CITY of NOVI CITY COUNCIL

Agenda Item 1
April 22, 2014

SUBJECT: Consideration for tentative approval of the request of Edward Rose and Sons for Rose Senior Living at Providence JSP13-81, for a Planned Suburban Low-Rise (PSLR) Overlay Development Agreement Application and Concept Plan. The subject property is 23.61 acres in Section 17 of the City of Novi and located on the north side of Eleven Mile Road and west of Beck Road. The applicant is proposing a 182 unit senior living facility.

FIGURE 6A: PROPOSE CARPORTS IN THE INTERIOR SIDE YARD (SOUTHWEST)

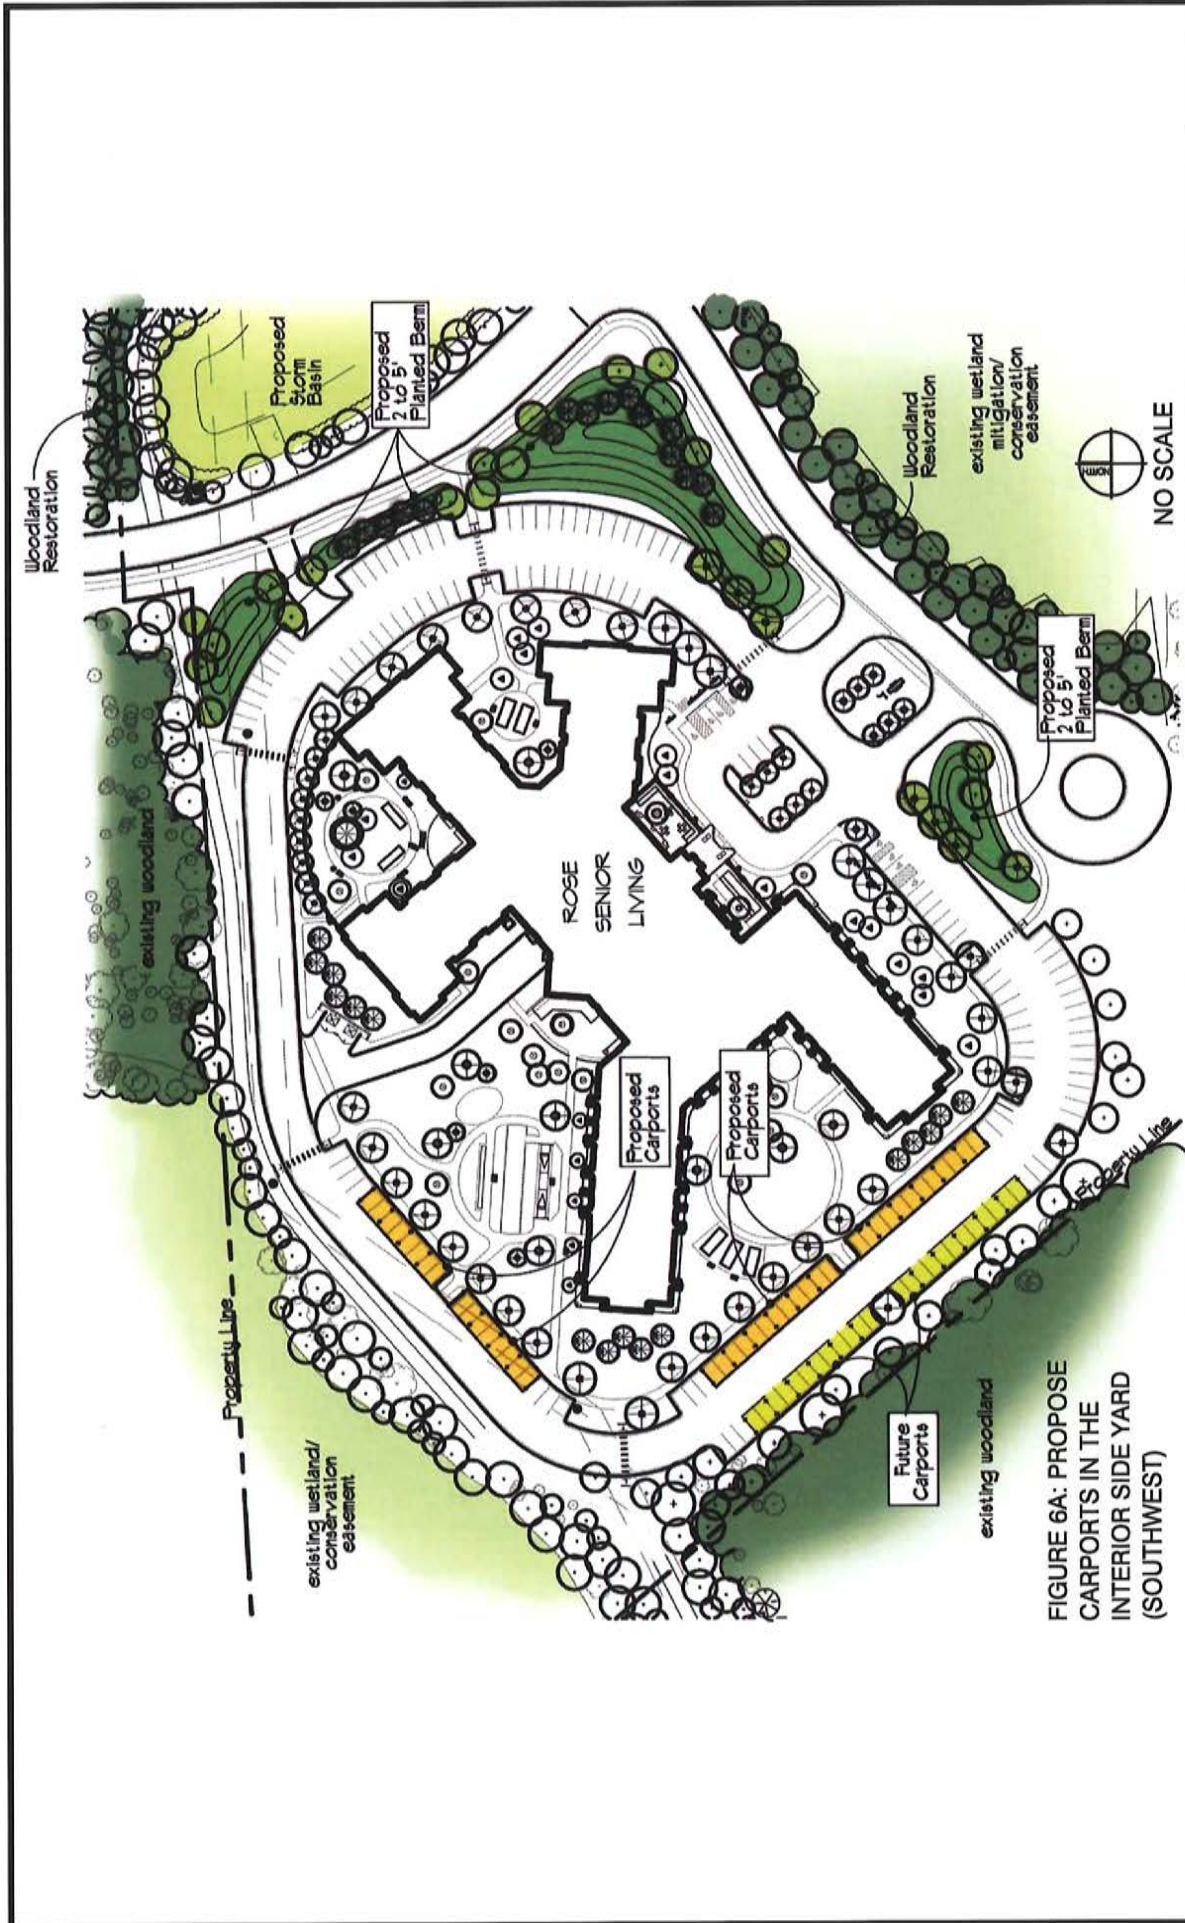
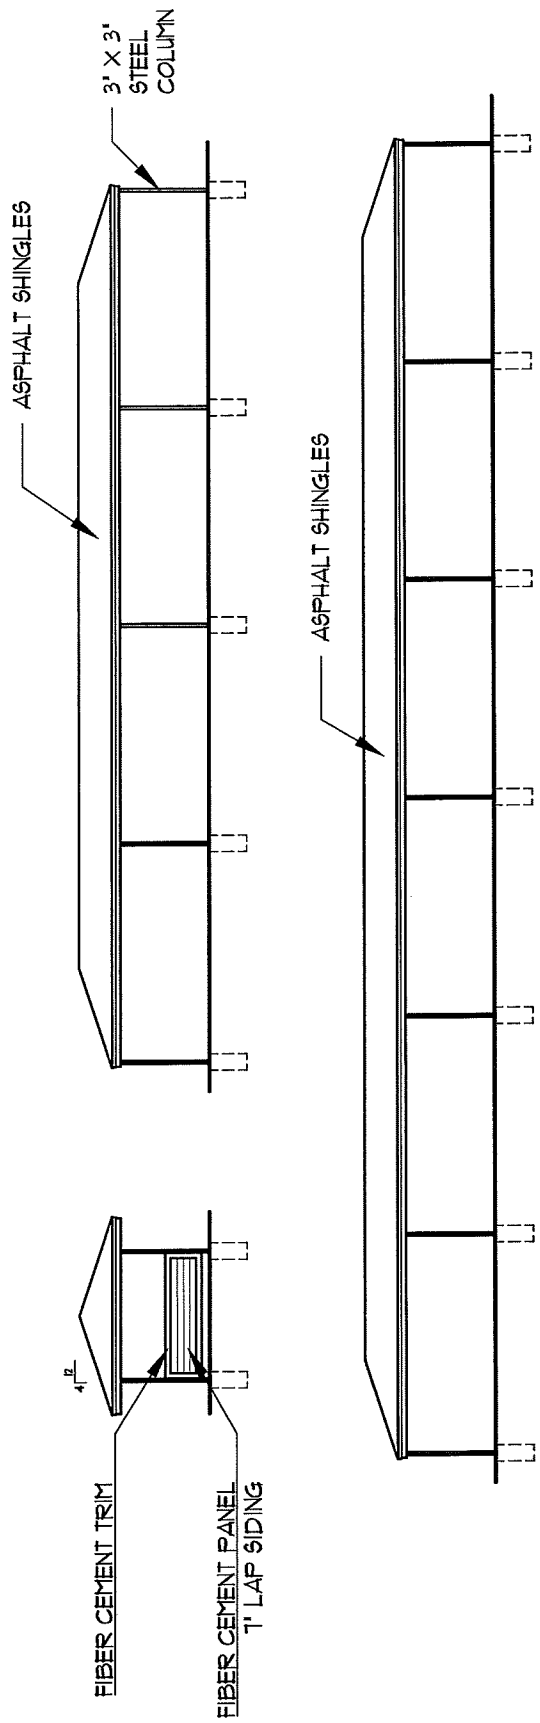
Narrative: Carports meet required setbacks and are buffered from adjacent properties and roads by natural features such as wooded wetlands, woodlands, and screened by 2 to 5 foot tall berms planted with both evergreen and deciduous canopy trees.

Graphic Depiction: Figure 6A and 6B attached and detail 3 on sheet A3.5 and sheet L302 show a graphical depiction of the carports proposed in the interior side yard (southwest) and illustrate the elements described in the narrative.

FIGURE 7A:
PROPOSE TWO
ON-PREMISE SIGNS

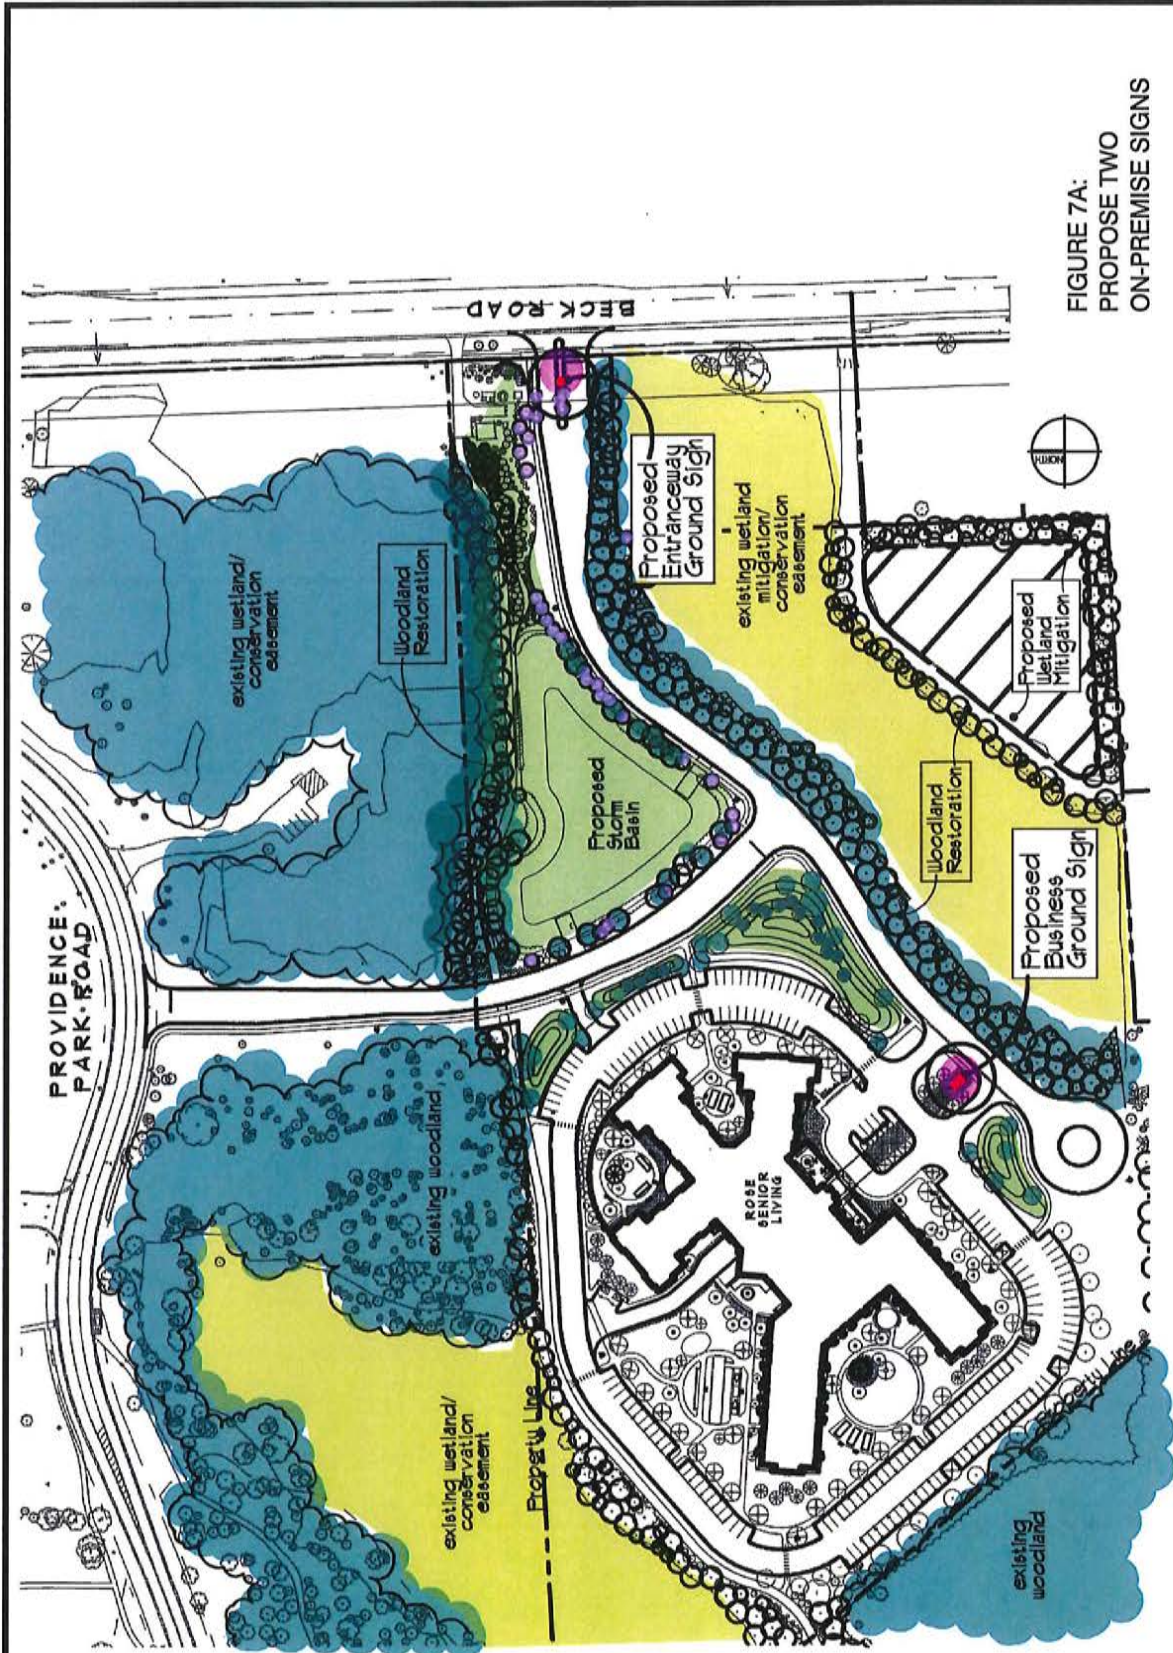
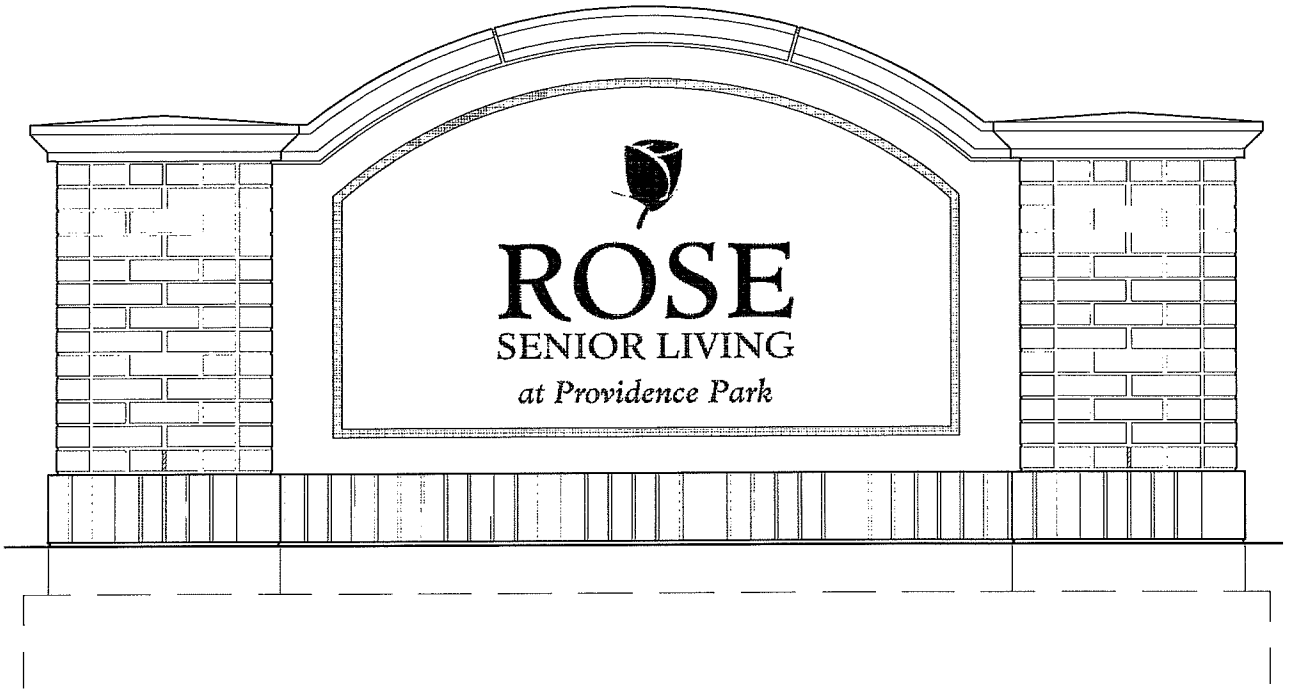
Narrative: Due to the long distance from the proposed advertising/ground sign located at the senior living building to Beck Rd. (600 feet) and Providence Park Dr. (680 feet) in addition to the amount of existing and proposed natural features (wetlands, woodlands, storm basin, berms, plantings, etc.) the applicant requests to provide one additional sign (entranceway) to clearly announce, identify, and provide direction to the senior living community's entrance.

Graphic Depiction: Figure 7A and 7B attached and plan sheet L402 show a graphical depiction of the proposed signage and illustrate the elements described in the narrative.

FIGURE 10: PROPOSED DOWNWARD SLOPE AWAY FROM ROAD

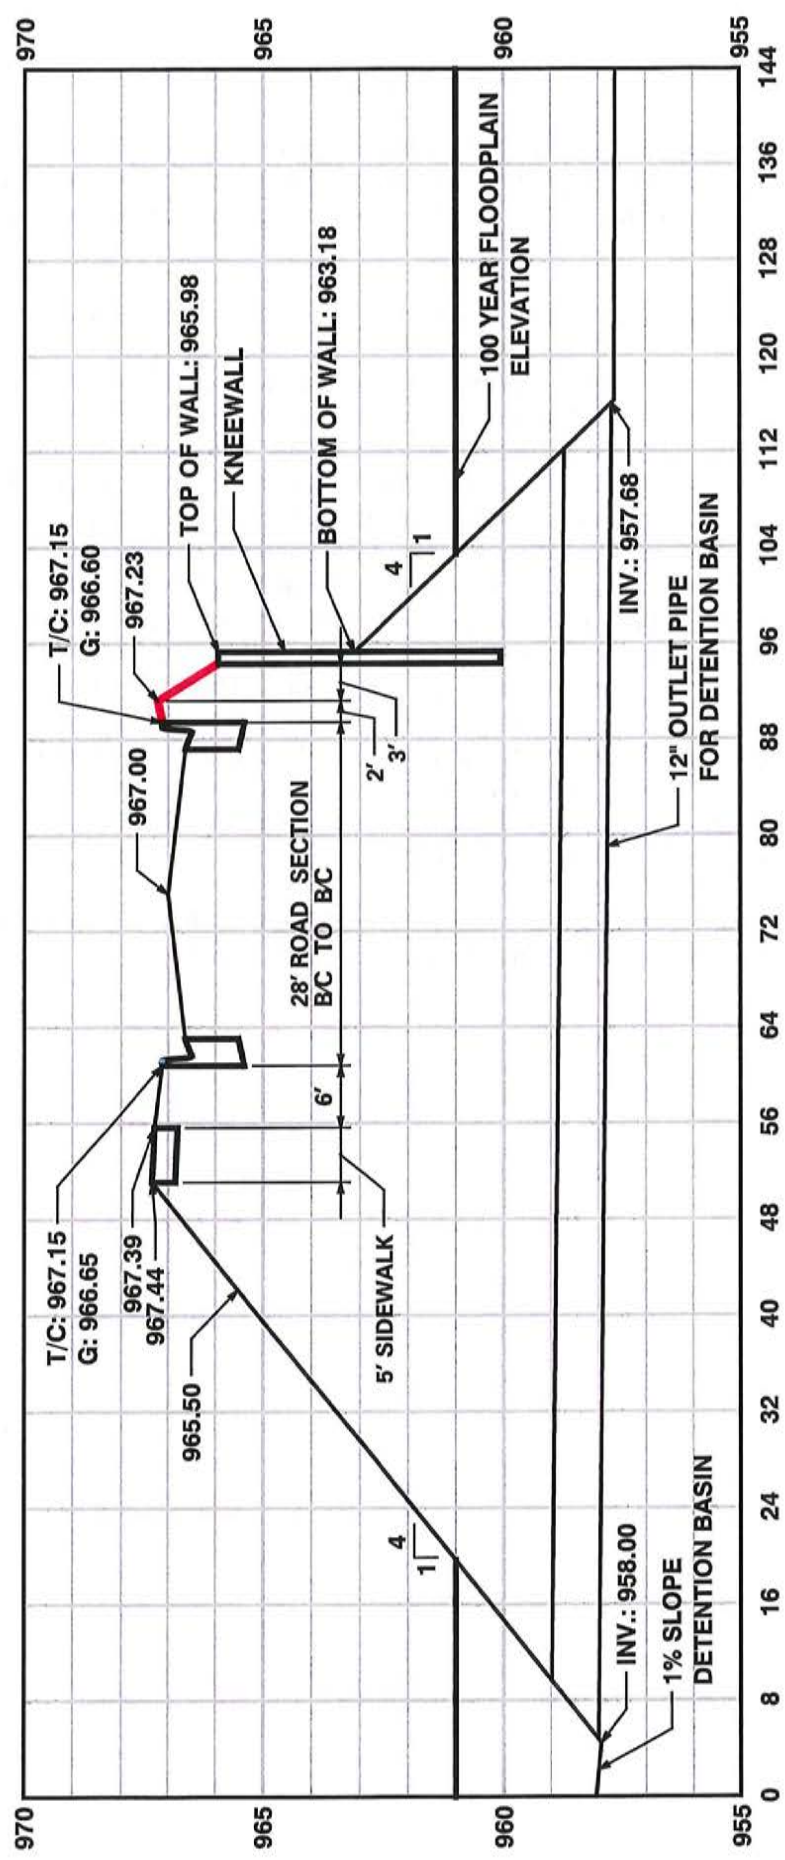
Narrative: The proposed grading plan provides a downward slope away from the proposed roadway that drains into existing mitigated wetland areas on portions of the proposed roadway to minimize impacts to natural features. As a knee wall is required to make the transition between the roadway elevations required and the existing mitigated wetlands to the south of the proposed roadway, the need to minimize the height of the wall and allow the proposed roadway to blend better back to the existing conditions is necessary.

Graphic Depiction: Figure 10 attached and plan sheets C07 and C08 show a graphical depiction of the proposed roadway cross-section and illustrate the elements described in the narrative.

WAIVER 1A: PROPOSE 2' HT. TO 5' HT. UNDULATING BERM TO SCREEN OFF-STREET PARKING WITHIN FRONT AND EXTERIOR SIDE SETBACK AREAS

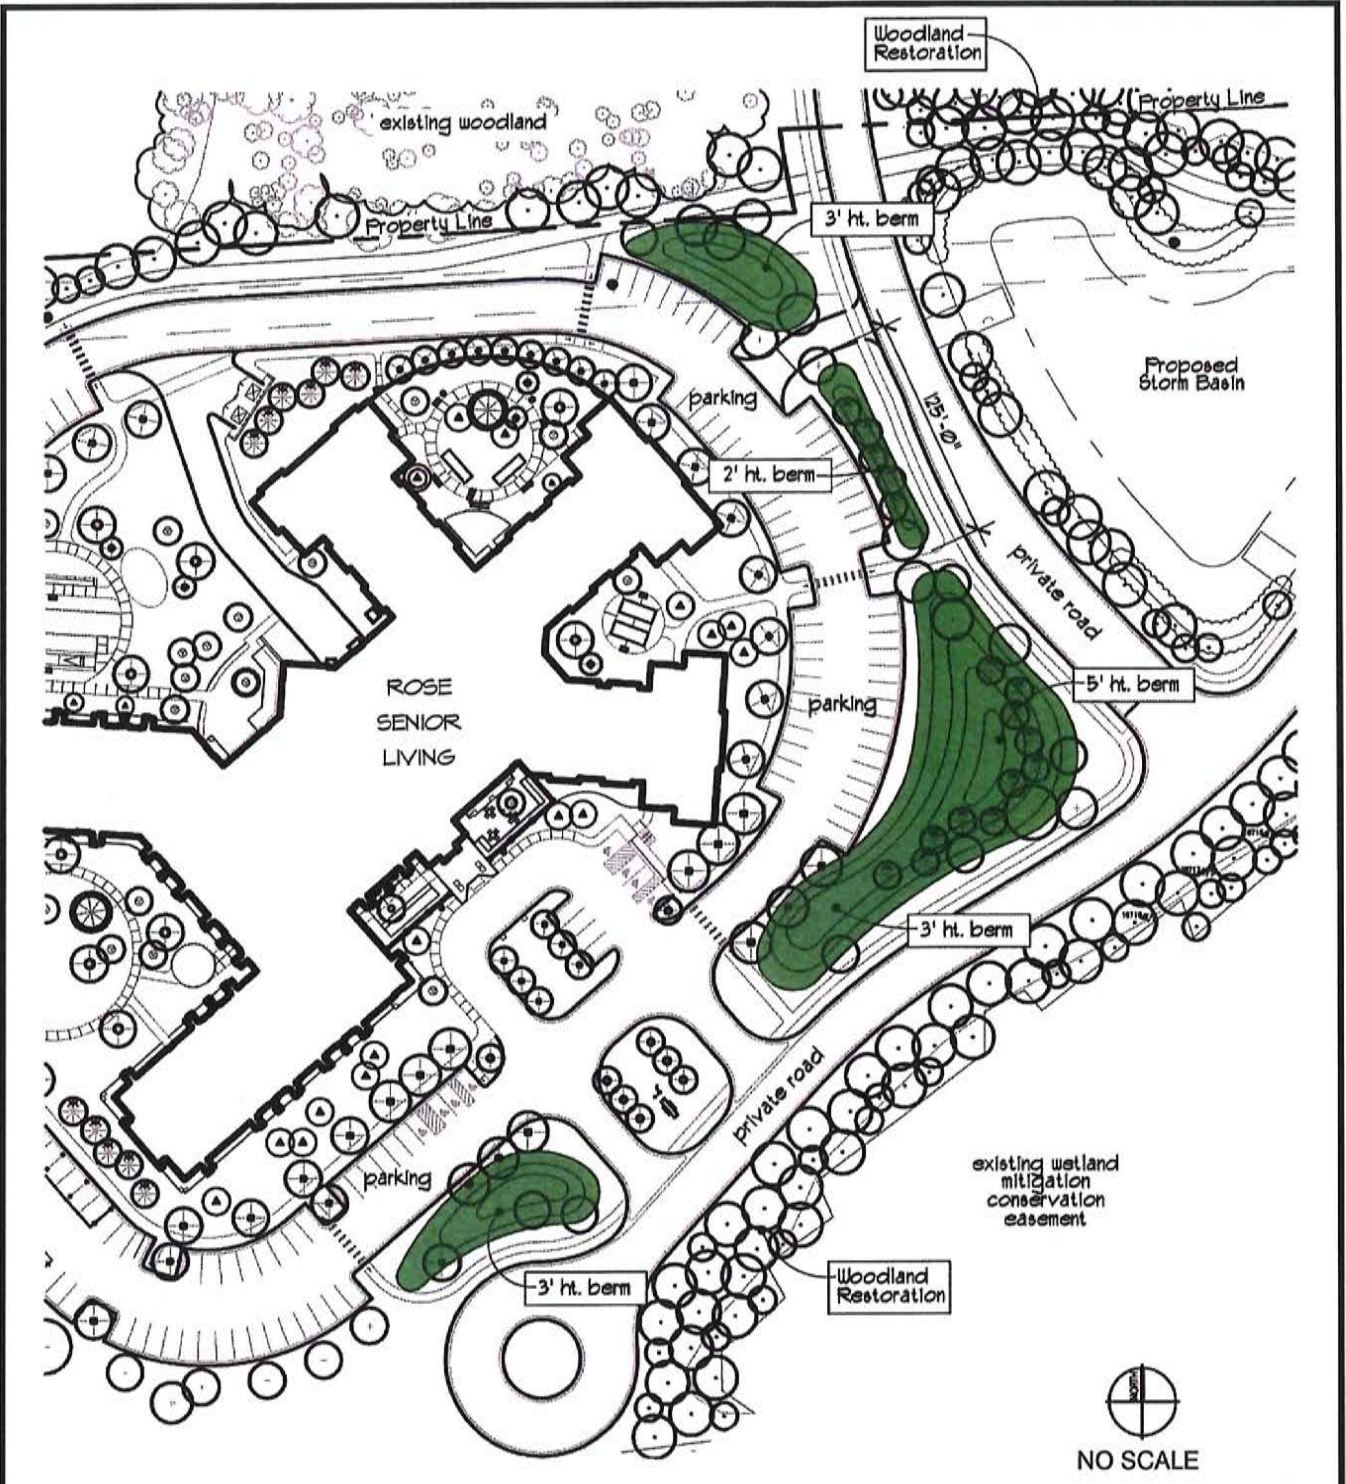
- A. [2305B(1)(d)] Off-street parking shall be screened from the view from adjacent streets by a 3 to 5 foot tall undulating landscape berm as provided in the landscaping standards of Section 2509.3.
- B. [2305B(1)(c)] A 3 to 5 foot tall undulating berm within a 50 feet wide greenbelt fronting Beck Rd. as provided in the landscaping standards of Section 2509.3.

- A. A 2 to 5 foot tall undulating berm between the proposed parking area and the proposed road.
- B. A 1.5 foot tall min. to 4 FT tall max. decorative wall fronting Beck Rd. in lieu of the required berm along the frontage.

Graphic Depiction: Figure “Waiver 1A” and “Waiver 1B” attached and plan sheet L201 show a graphical depiction of the proposed berms and decorative wall that illustrate the elements described in the narrative.
